HOMESTAKE MINING COMPANY PITCH PROJECT

FINAL ENVIRONMENTAL STATEMENT

USDA FOREST SERVICE - ROCKY MTN. REGION
GRAND MESA, UNCOMPAHGRE, GUNNISON N.F.

Fig. 2.5. Groundwater regime of the project area. Source: ER Suppl., Plate 2.6-1, p. 2-11.

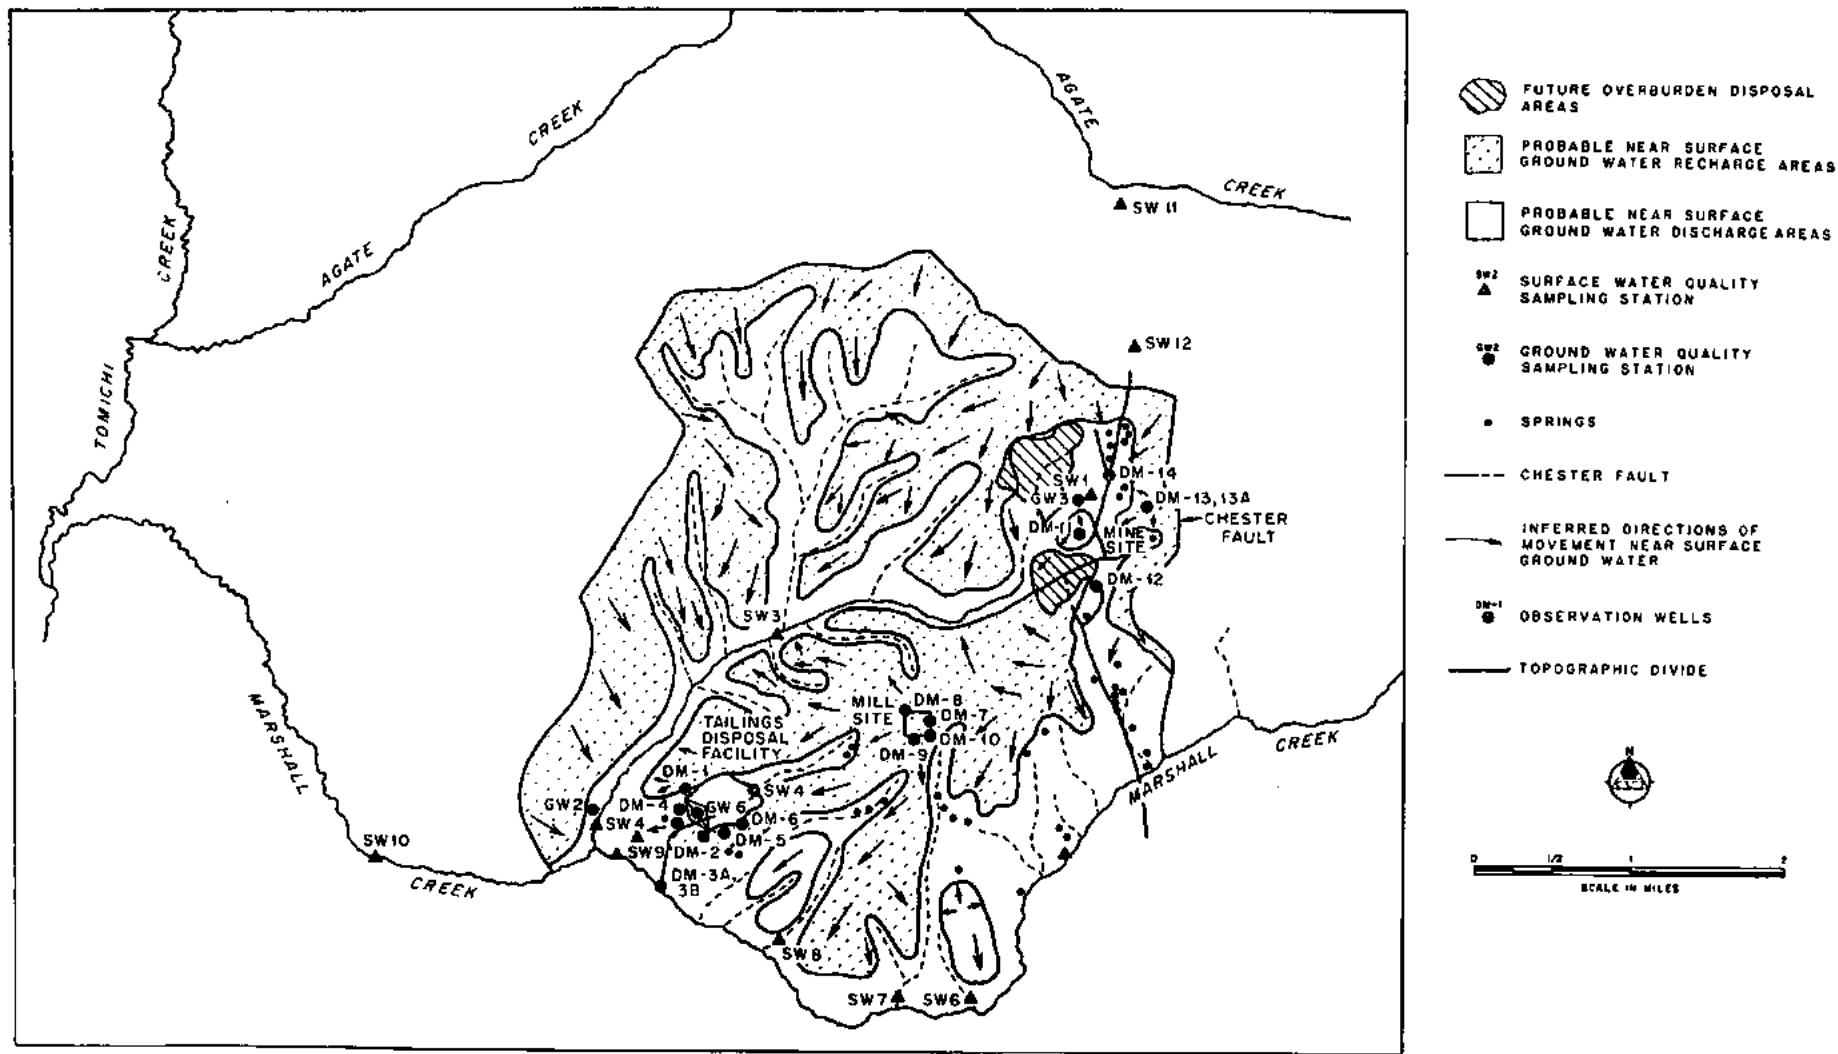
4. Page 2-8, Figure 2.5: The figure is essentially illegible, making it impossible to locate the sampling stations.
5. Page 2-12, Table 2.4: The recorded water levels on selected dates in the monitoring wells during September 1976 to January 1977, represents a very limited record and fails to document changes in water levels as a result of the important spring recharge. Additional groundwater recharge data is needed.

Fig. 2.6. Piezometric surface in the mine and waste dump area and monitor well locations.

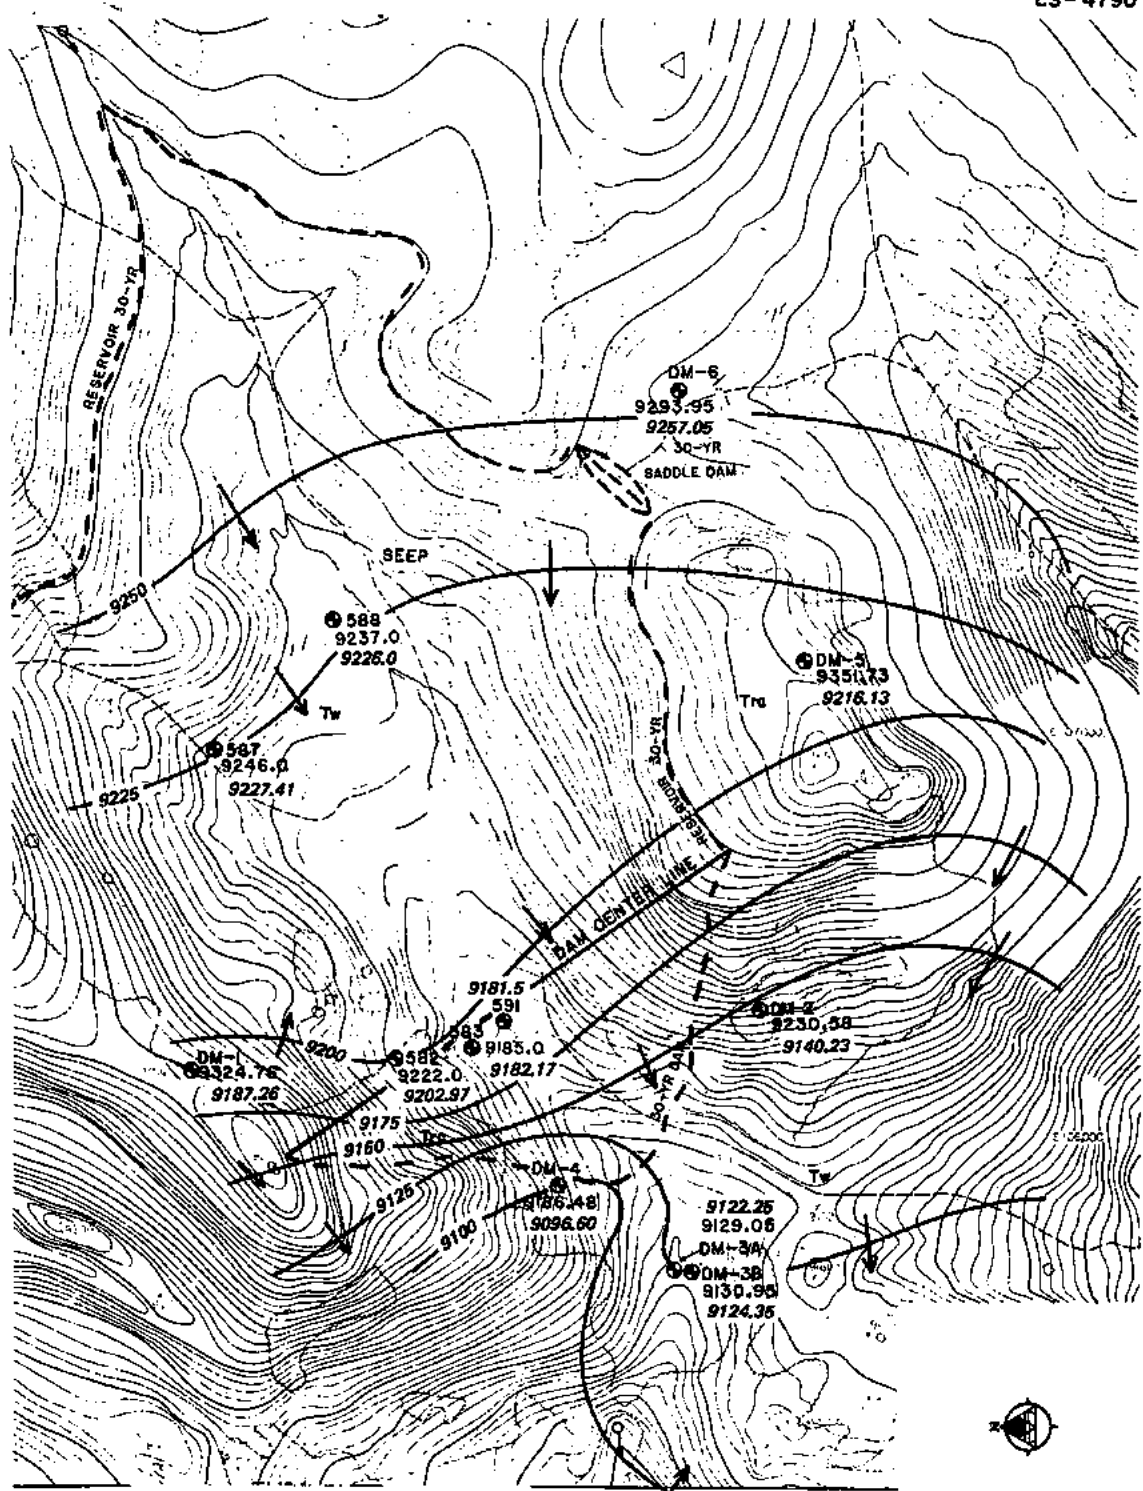
Figure 2.6, page 2-15, demonstrates groundwater presently stands at the expected lake level over the ore body. The alleged "tremendous pressure" is presently doing to groundwater flow what the lake level will.

The groundwater piezometric surface maps in Fig. 2.6 and 2.7 together with water level changes with time in Table 2.4 demonstrate no flow abnormalities indicating rapid water transport offsite. They also indicate the planned monitoring system should be effective.

2. Groundwater will not affect the waste dumps. The hydrological regime at the mine and waste dumps is demonstrated in Fig. 2.6 and Table 2.4. Potential impacts of the waste dumps are discussed in Sect. 4.
3. This is not a contradiction. Groundwater inflow into the open pit may be as low as 1000 m³/day (190 gpm), a small amount of groundwater by aquifer flow concepts but, together with runoff, sufficient to maintain a 72-ha (29-acre) lake.
4. This was discussed in Sect. 6.2.1 of the DEIS and has been amplified in the FES and in the responses to State of Colorado comment 20 and EPA comments 3, 24, 42, and 51. The lake water quality is expected to be suitable for livestock use and public recreation. If not, access will be restricted.
5. This issue is discussed in Appendix C. In addition, refer to Sect. 10.6, which has been updated for the FES.

Fig. 2.8. Location map for groundwater investigation: mill site. Source: ER Suppl., Plate 2.6-3, p. 2-19.

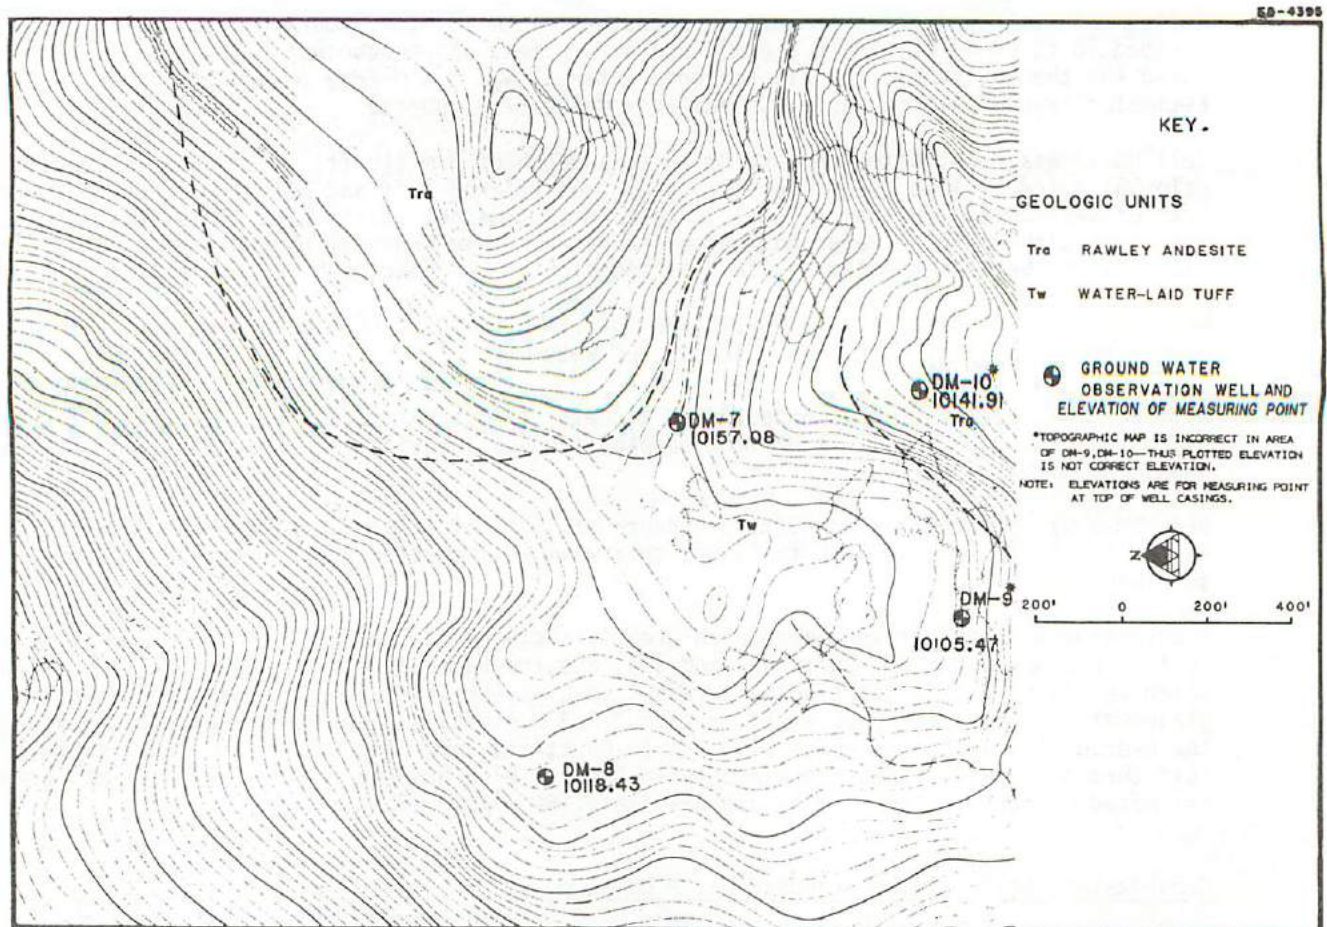
8. Page 2-15, Figure 2.8: The locations of the groundwater sampling stations (GW-1 to GW-7) are not shown in this figure.
9. Pages 2-16 through 2-18, Tables 2.5 and 2.6: What is the explanation for the high TSS concentrations in the groundwater samples listed in Table 2.5? Why isn't the pH included in Table 2.5 or 2.6?

Fig. 2.9. Relationship of Indian Creek and Marshall Creek to project area. Source: ER, Plates 2.6-1 and 3.6-3, pp. 2-127 and 3-45.

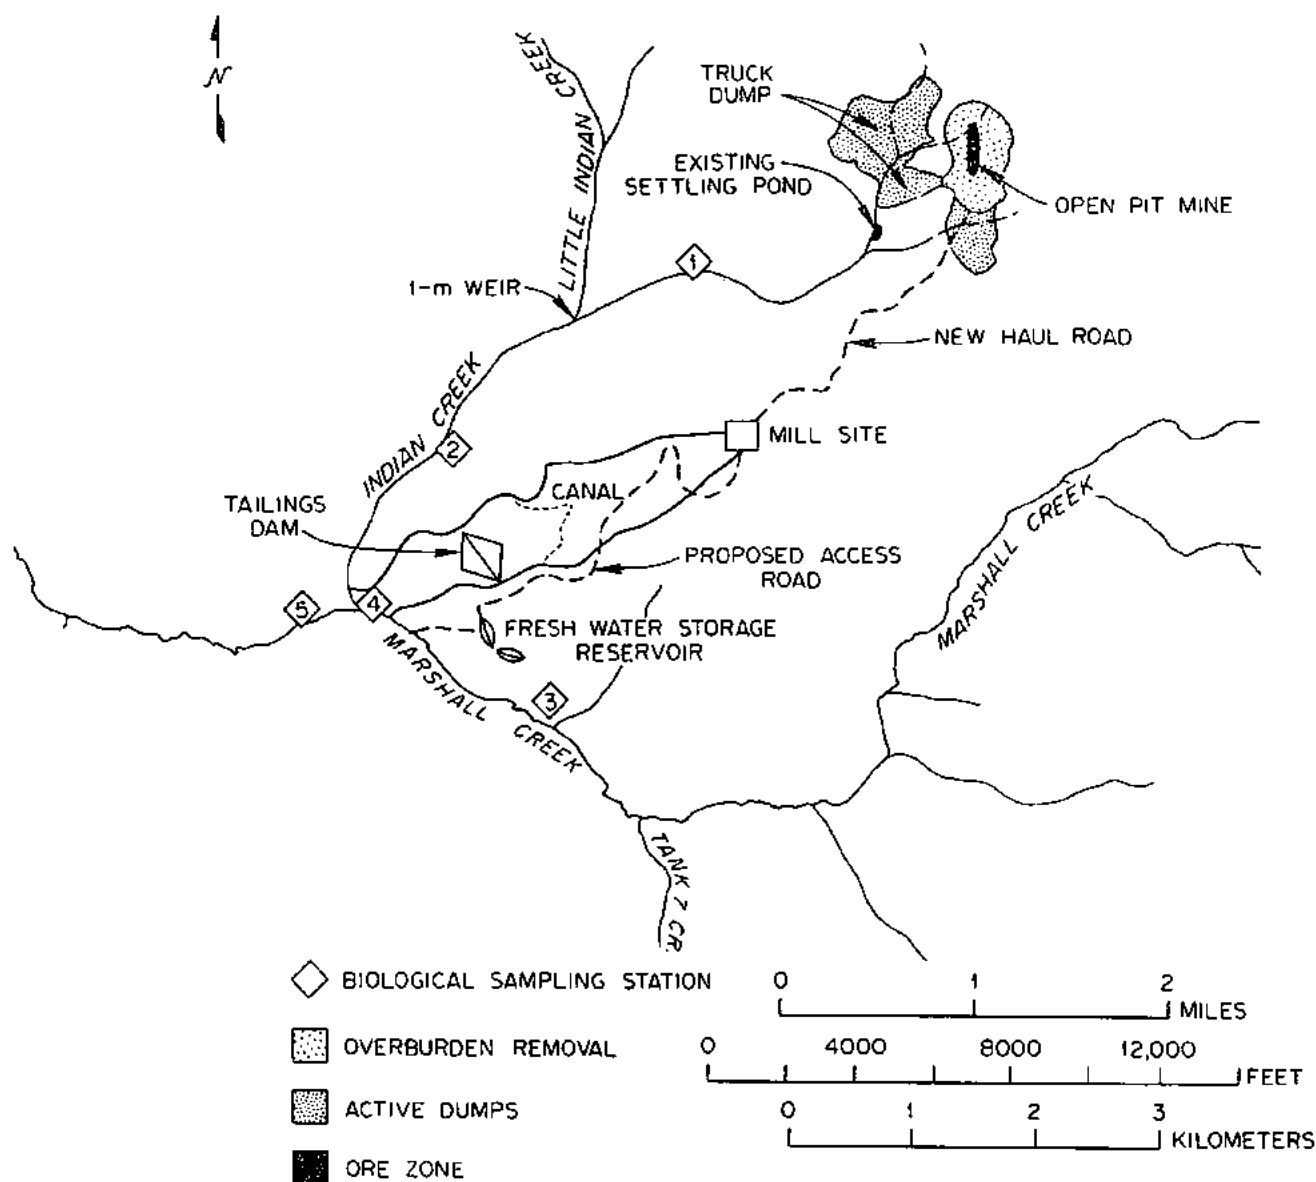
11. Page 2-20, Figure 2.9: The existing Pinnacle Mine operations should be included in Figure 2.9. The text in Section 2 should describe the existing Pinnacle Mine conditions and wastes.

7. The statement is based on personal observations by the staff.
 8. The location of Tank 7 Creek has been added to Fig. 2.9. Additional streamflow information has been added in Sect. 2.4.2.2. Potential impacts have been addressed in Sect. 4.3.3.

11. The Pinnacle Mine is not operating. Groundwater monitoring site GW-3 on Fig. 6.1 monitors the discharge from the Pinnacle Mine portal. The quality of this water is reported in Table 2.6. Figure 2.4 also shows the mine location. The ion-exchange circuit is now dismantled. Most of the buildings remain and are being utilized for storage and some warehousing and maintenance shop usage. Areas utilized by the ion-exchange plant for the processing of yellow cake are presently boarded off and closed to entry. Some ore from Pinnacle mining remains in a stockpile constructed by Pinnacle. Existing waste generated by the previous underground mining of Pinnacle will be disposed of in the proposed mine waste dumps.

Fig. 3.12. Estimated water balance for Pitch Project.

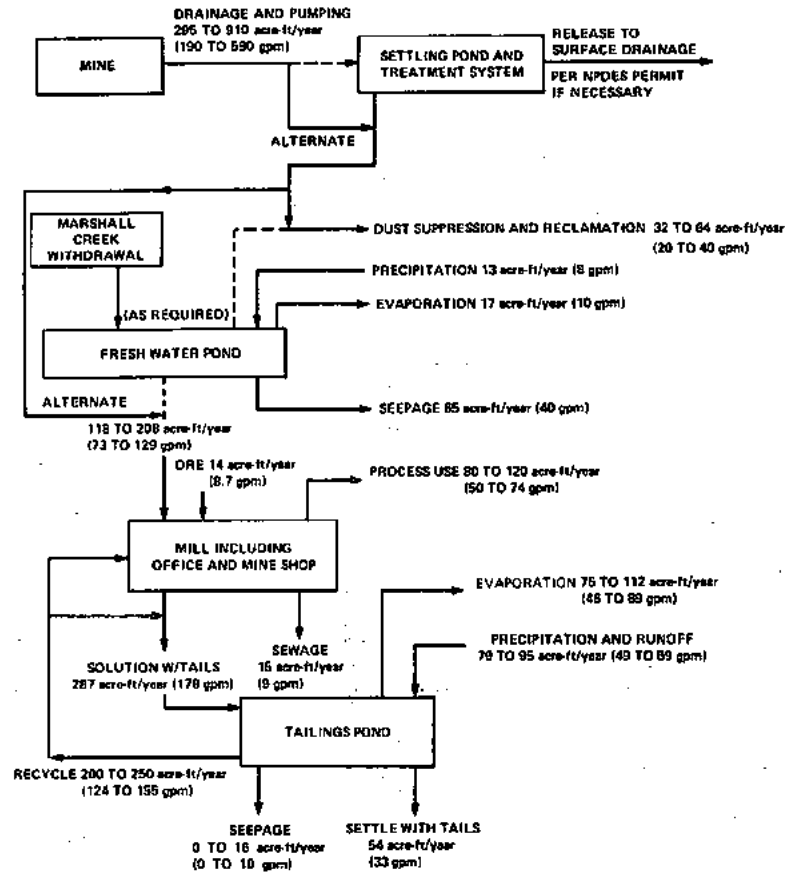
30. Page 3-21, Figure 3.12: Contrary to the texts of the Environmental Report and the DES, the dewatering effluent is depicted as primarily a discharge to surface drainage and only as an alternate mill process water source. Is this correct? The dewatering effluent should be used as an alternate. This will eliminate or reduce treatment costs and decrease the use of Marshall Creek water. What are the units?

39. Page 4-5, Section 4.3.3., Water Use: The statement "The applicant is planning to use recovered mine groundwater as milling process water . . ." is not in agreement with Figure 3.12.

30. Mine water from the open pit will be used in the mill circuit as needed. Only excess mine water that is not used in the mill circuit will be discharged. Prior to discharge, the water will be treated, if necessary, for radium removal and then released to the new sedimentation pond for suspended solids removal. The units referred to in Fig. 3.12 are acre-feet. This figure has been updated. (See response to comment 29 above.)

39. The applicant will use mine water in the milling process. Figure 3.12 has been modified accordingly. Mine water in excess of that required in the mill circuit will be treated for radium removal, if necessary, and released to the sedimentation pond. Fresh water demands will be met using the fresh water storage pond. (See responses to comment 30 above, State of Colorado comment 42, and EPA comments 30 and 45.)

Fig. 6.1. Radiological preoperational monitoring program sampling sites. Source: ER, Plate 6.1-1, p. 6-50.

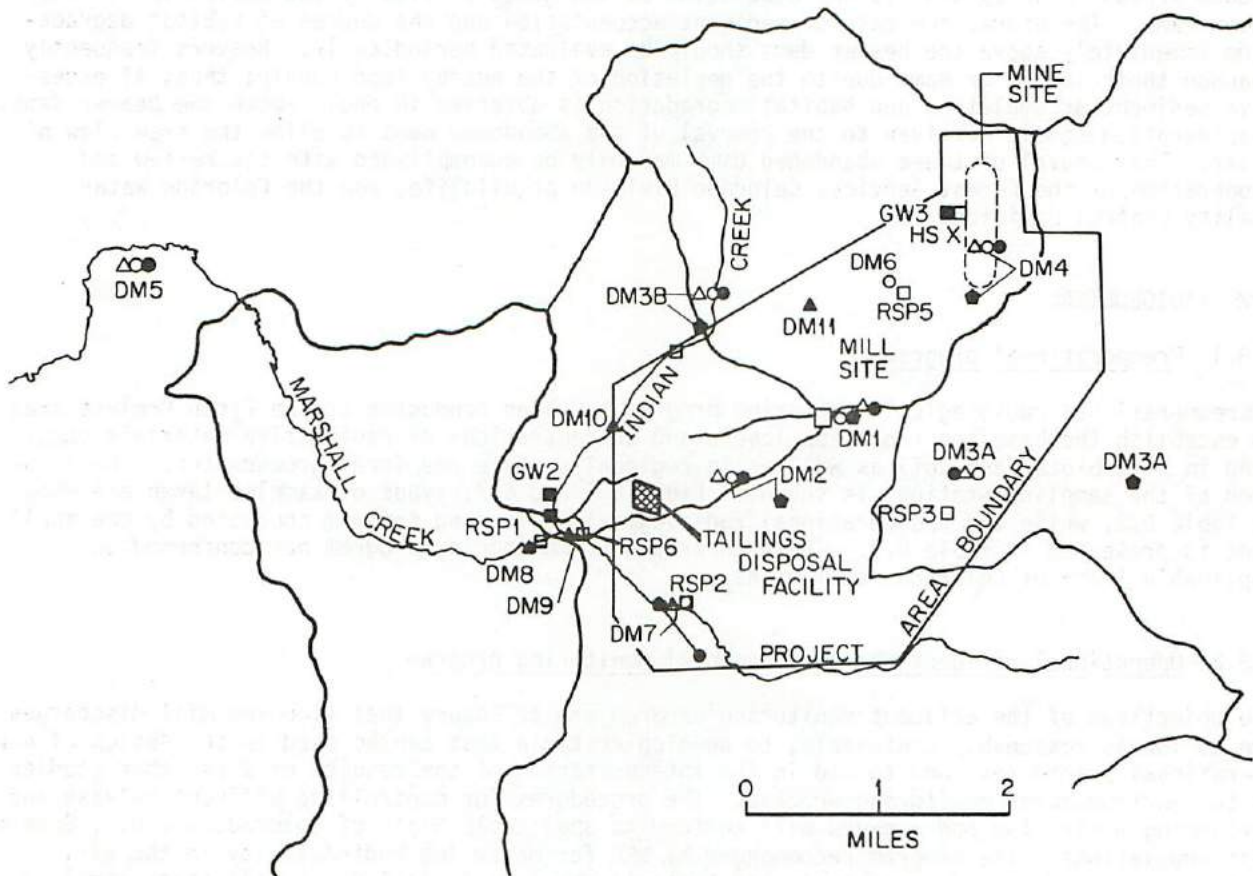
58. Page 6-9, Figure 6.1: This map is difficult to read. It should be enlarged and the contour lines removed. The only required features are the surface drainages and the major sites of the Pitch Project (i.e., mine site, mill site, and tailings disposal pond site). It also would be helpful to illustrate the sampling sites by related types on two additional figures: (a) surface water and sediments, aquatic biota, and ground water; and (b) air, soil, vegetation, and terrestrial animals.

58. Figure 6.1 has been revised to improve legibility.
59. Table 6.4 presents the operational radiological monitoring program for the mill. The Colorado Department of Health will require an ongoing monitoring program of the mine waste dumps. Details will be in the license.
